PSP 1067 & 1096

Donnybrook / Woodstock

Precinct Structure Plan

Part B Submission - GC28
Amendment to the Whittlesea
and Mitchell Planning Scheme

Issue 1. Review of Conservation Area Boundaries

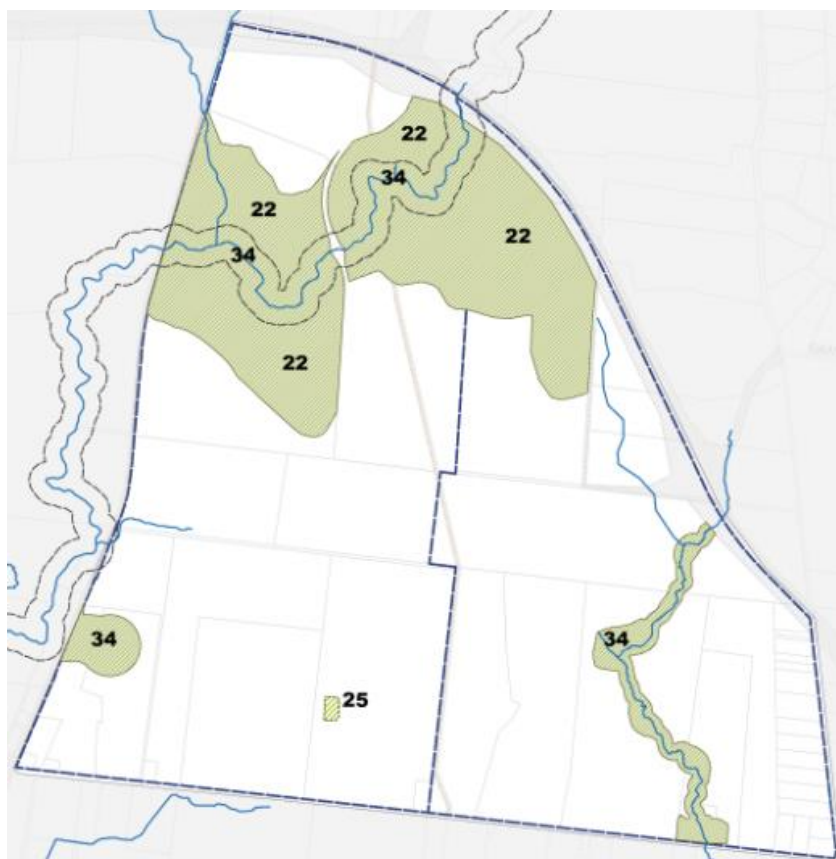
DFC request a note on plan /text to add.:

‘The Conservation Area boundary may change with the appropriate approvals from DELWP /Commonwealth as required under the Melbourne Strategic Assessment.’

The Conservation Area Concept Plans (CACPS) will be updated when the revised boundaries are identified. It should also be noted that any increase in developable area associated with a reduction in Conservation Area will be subject to the payment of native vegetation offsets and the City of Whittlesea’s tree retention policy.

Until such time this review is completed and approved, the MPA can only show the current designated BCS boundary.

Issue 2 – Heffernan Property, time stamping of vegetation

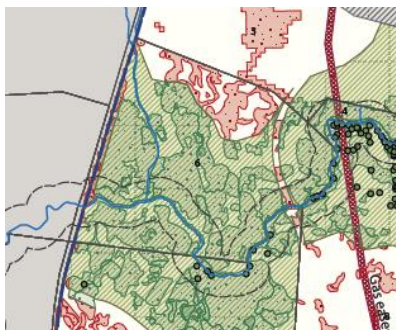
Mr Heffernan is concerned that the native vegetation values placed on his land were greatly exaggerated when time stamped.

The time-stamping project brings together native vegetation assessments of the growth corridors conducted since 2008 by the former Growth Areas Authority, Department of Transport, and DEPI in consultation with the former Department of Planning and Community Development. Many properties in the growth corridors were surveyed by consultants under contract to the Growth Areas Authority (for precinct structure planning) or Department of Transport (for the Regional Rail Link project). The time-stamping project completed the mapping across the growth corridors by consulting directly with landowners of properties that had not been surveyed through these projects.

In cases where field assessments have not been done, the former DEPI has consulted directly with landowners, who were given an opportunity to review and revise the department's understanding of the native vegetation on their properties.

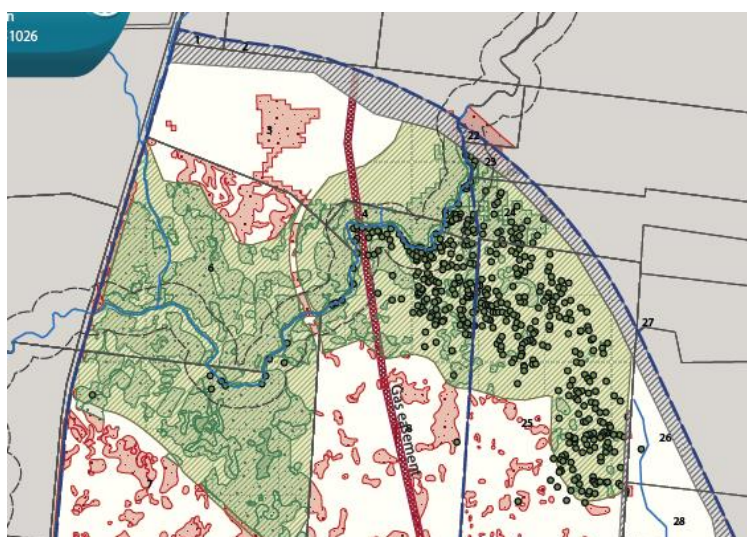
FOMC consider there is a substantial area of high quality endangered native vegetation immediately to the north of the conservation area that is not protected. This vegetation can be removed according to Plan 8, current draft PSP. The adjoining conservation areas in the north of the precinct contain biodiversity values of national and state significance, and protect the Merri Creek corridor.

FOMC Recommends that the area be protected and more of the high-quality endangered native vegetation adjoining the northern edge of conservation area 22, west of Patterson Drive.

The review of BCS Open Space Conservation Area 22 is currently being reviewed by DELWP through survey work. The amendment adopts the current Victorian planning policy and the BCS unless they are approved prior to the adoption of this PSP.

Issue 2- Request for additional retail floor space at the Monteleone Property

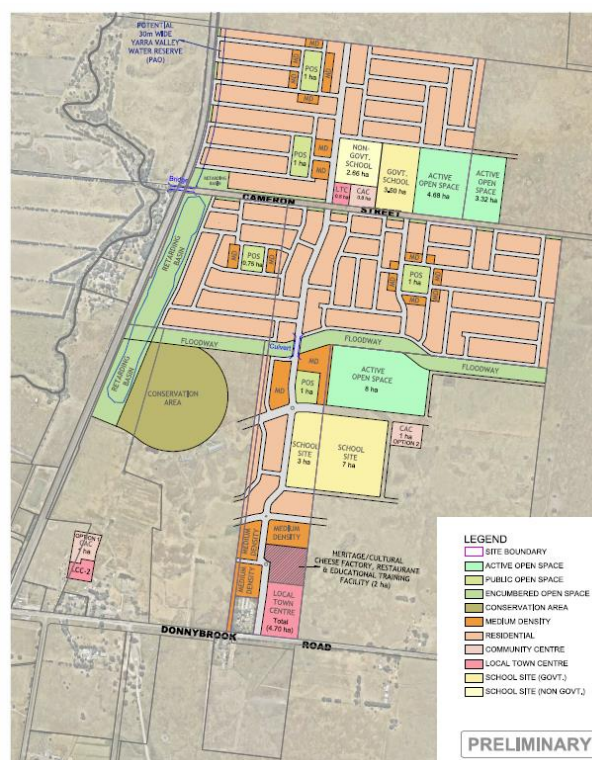
In their submission, the Monteleone family have sought:

- the relocation of LCC-1 to the southern portion of their land, fronting Donnybrook Road;
- an increase in its floor area to a soft cap of 2,500 sqm;
- the relocation of LTC-3 adjacent to Cameron Street; and
- a reduction in its floor area.

The PSP Guidelines concerning Town Centre Design set a standard that 80-90% of households should be within 1km of an activity centre of sufficient size to allow for provision of a supermarket. In response, the PSP nominates 400 m and 1 km catchments for retail areas.

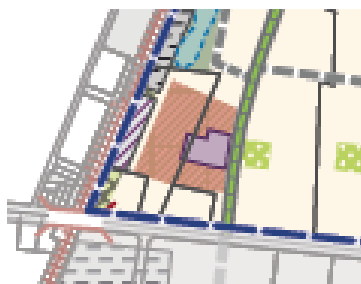
FDTS request it be changed to accommodate only retail and convenience stores of less than 1000m2.

The FDTS has concerns about the capacity of the Supermarket to meet the needs of a growing community.

The FDTS recommend a full and complete economic assessment of the viability of the Donnybrook Train Station commercial precinct

The MPA does not support this recommendation. The distribution of LTC's and LCCs has been assisted by the application of sound planning principles throughout the precinct. The owner of the site has indicated that they support the scale of the LCC and intend to develop generally in accordance with the vision of the PSP. Furthermore, it is considered appropriate to plan the centre to achieve its highest and best land use outcome (i.e. a mix of high density/mixed use development). This will ensure that activity can be maximised in this strategically important site. The retail has been located in this location to capitalise on the station activity, traffic movement and land-use outcomes.

Existing floodplain for a tributary of Merri Creek

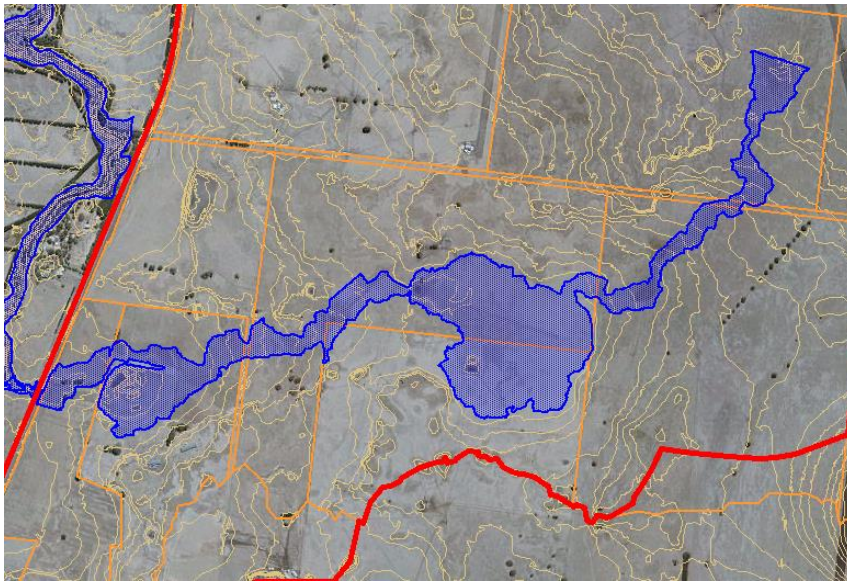
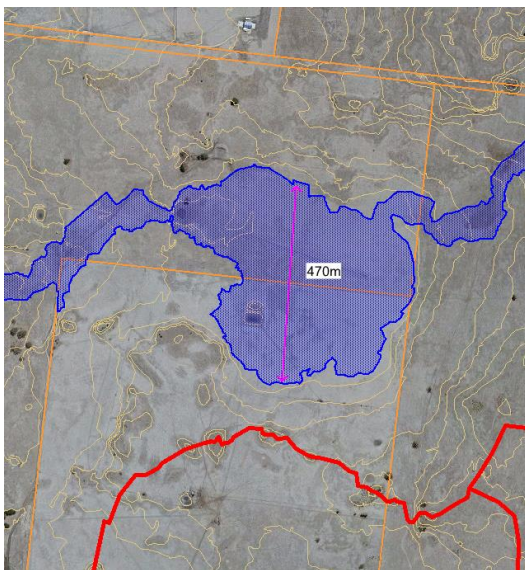
The image below shows the existing floodplain extent for a tributary of the Merri Creek within the Lockerie East DSS in rural conditions. The existing flood extent covers an area of approximately 40ha across multiple properties for 2.7km. The largest width of the floodplain is approximately 470m between the Monteleone and Dibella properties. The Lockerie East DSS incorporated a waterway and retarding basins design that will free up land for future development. The discharge from the retarding basin RBWL1 immediately east of the railway line controls the 1 in 100 stormwater runoff to the capacity of the existing culverts across the railway.

Changes made to RBWL2 and why RBWL2 cannot be located within Mirvac property at this location

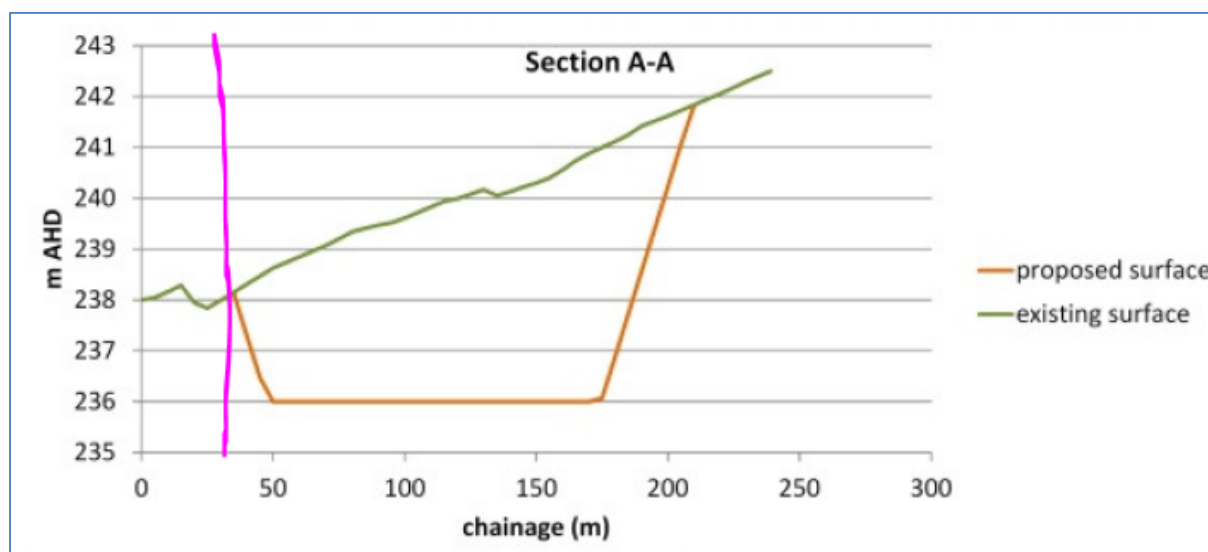
The wetland footprint area is about 2ha and 0.4ha and the total land take (including retarding basin) is about 2.9ha and 0.5ha within the Monteleones and Di Bella's properties respectively.

An engineering feasibility was undertaken by Mirvac on the design of RBWL2 across two properties. By locating RBWL2 within the Mirvac property at this location, further excavation would be required resulting in additional construction costs that would be added to the Development Services Scheme contribution rates. This is because:

By locating RBWL2 within the Mirvac property at this location, further excavation would be required resulting in additional significant construction costs that would be added to the Development Services Scheme contribution rates. The location of this retarding basin would not be optimal, and would only be justified in benefiting the Monteleone, at the expense of the rest of the developers/landowners in the Lockerbie East DSS who would be charged a higher DSS contribution rate.

Growling Grass Frog bulge

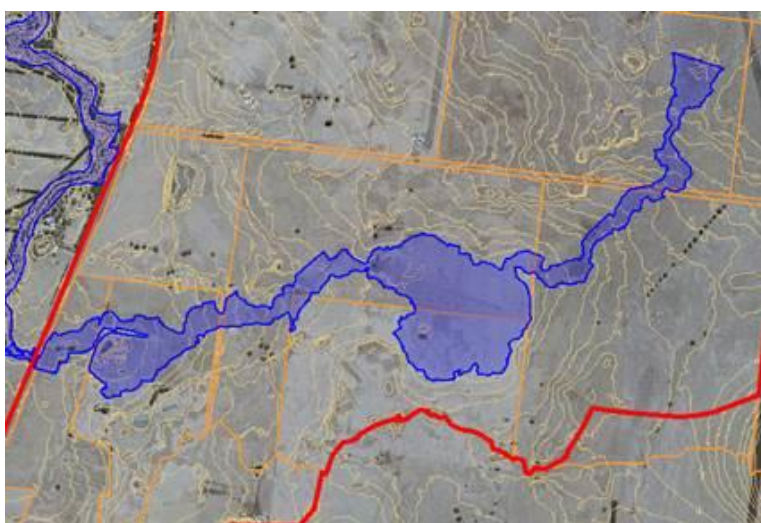
Minimal drainage works have been located within this conservation area following consultation with DELWP. The conservation area is part of DELWP's Biodiversity Conservation Strategy to protect Growling Grass Frog within the Merri Creek catchment. Based on discussions with DELWP, the majority of this area is to be protected and not impacted by drainage works as the conservation area will be utilised for the creation and enhancement for GGF habitat and terrestrial foraging habitat. The use of this area for a retarding basin and stormwater wetland would result in excavation of a large portion of the area, impacting on any future GGF habitat creation.

Existing floodplain for a tributary of Merri Creek

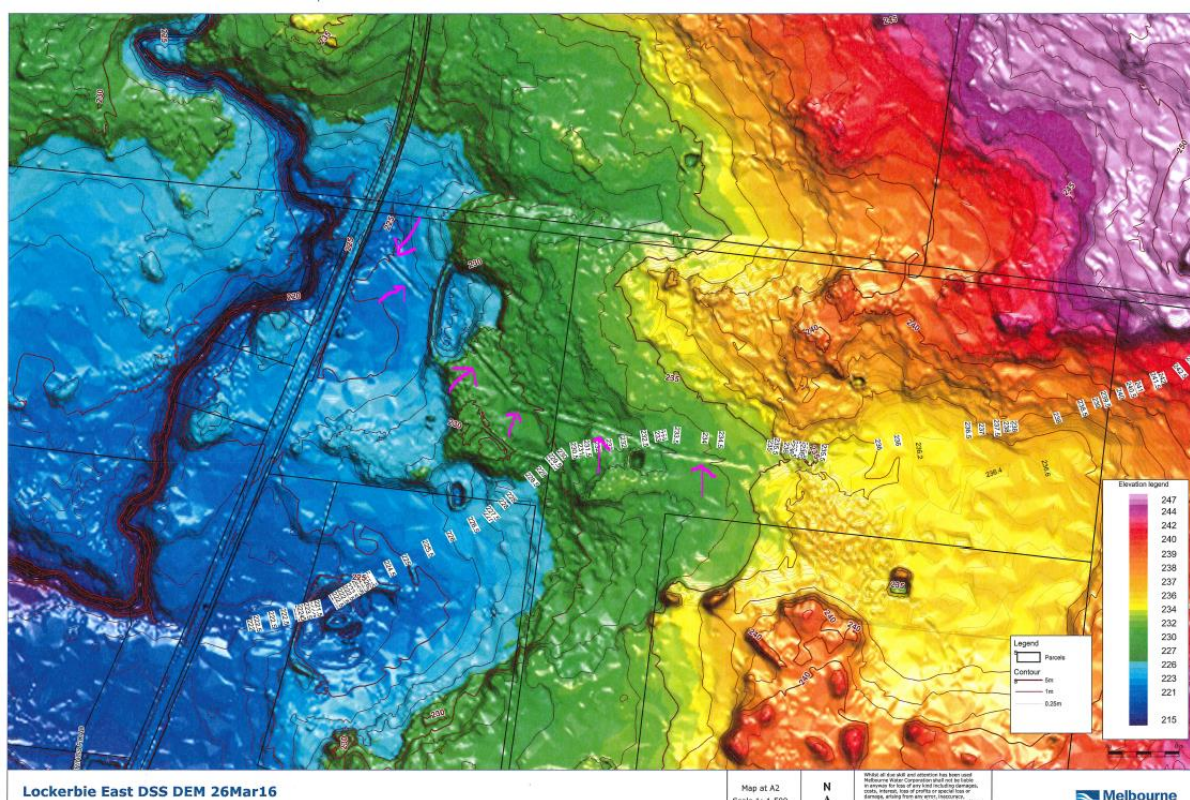
The existing floodplain for a tributary of Merri Creek shows a clear flow path for drainage within the Lockerbie East DSS in existing conditions. The flow path/flooding begins in the Boral/Mirvac property in the north-east, enters the Monteleone property and widens out across the Monteleone and Dibella properties, and then continues westwards primarily across the Monteleone property, into DFC and towards the railway culverts.

The Lockerbie East DSS has directed developed flows into RBWL1 and through the outfall at the Monteleone culverts. The reason for this is that these culverts have a larger capacity (12.5 m³/s) compared to the other two culverts.

The waterway corridor for CH1 has been reduced from 55m (as advised in the PSP Public Exhibition November 2015), to 45m. This is consistent with Melbourne Water's Waterway Corridor Guidelines where it is recommended that active edges (roads, vehicle access) are located outside of the waterway corridor along both sides of the waterway. Melbourne Water do not support direct frontages and back fences along the waterway corridor.

Submission 2 – M & J Harte

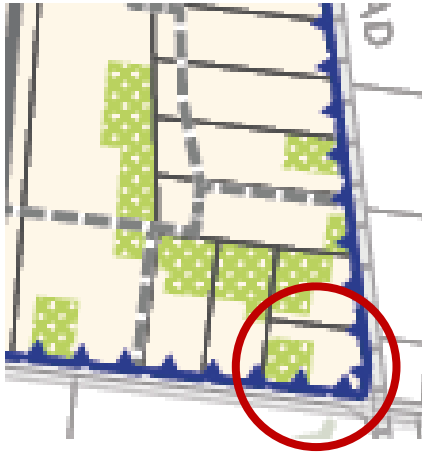
The Harte family submit that the designation of open space is not appropriate on the site as it is located on the intersection of two major roads of the South and Eastern Boundary of the PSP.

The location of LP25 is considered important to the future development of the Donnybrook/Woodstock PSP as it provides the opportunity to retain trees which have been identified as holding arboriculture and landscape values in situ and within public open space. Retaining trees in public open space, particularly on small sites facilitates the ability to reduce the financial impact on the landowner by retaining the trees on land, which is ultimately purchased by either the Infrastructure Contributions Plan (ICP) or via the provisions of Clause 52.01 of the Whittlesea Planning Scheme.

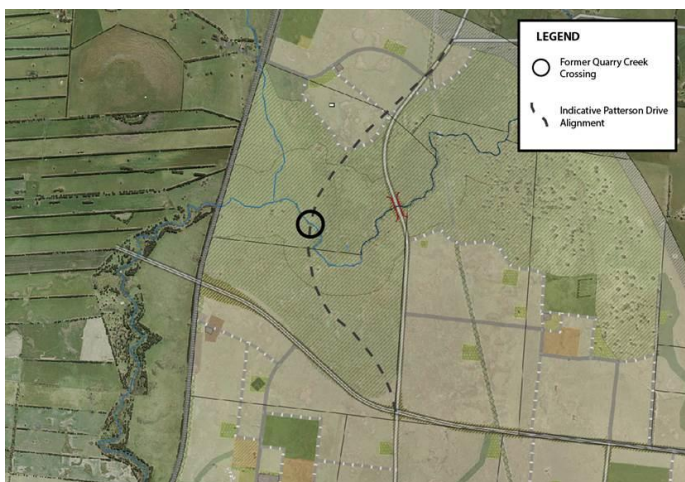
Mr Heffernan submits that the Patterson Drive bridge on the Merri creek is in the wrong place. He requests that Patterson drive should be on the same alignment as the existing bridge over the Merri creek and associated road.

We acknowledge that the bridge will be located in a deeper gully than the existing, however the location proposed also avoids the need to remove significant trees.

Submission 26 – Anthony Monteleone

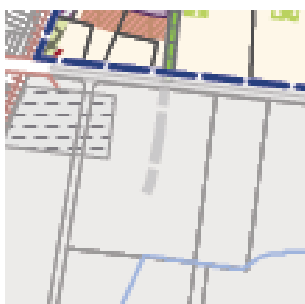
Mr Monteleone submits that there is a road alignment that goes through the existing dwelling and requests it to be realigned or moved.

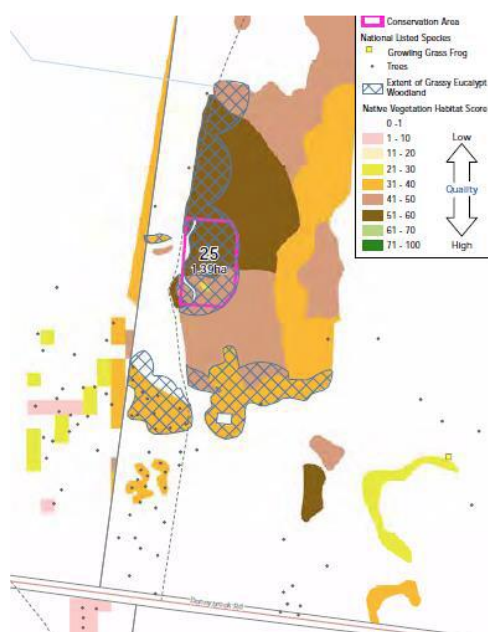
FOMC Protect the full extent of endangered Grassy Eucalypt Woodland near the central southern boundary of the precinct.

The woodland and stony knoll has been retained as an open space in the PSP and therefore the grassy eucalypt woodland will be retained as far as practicable. Since the City of Whittlesea have an 80% tree retention policy, most of the trees will look to be retained.
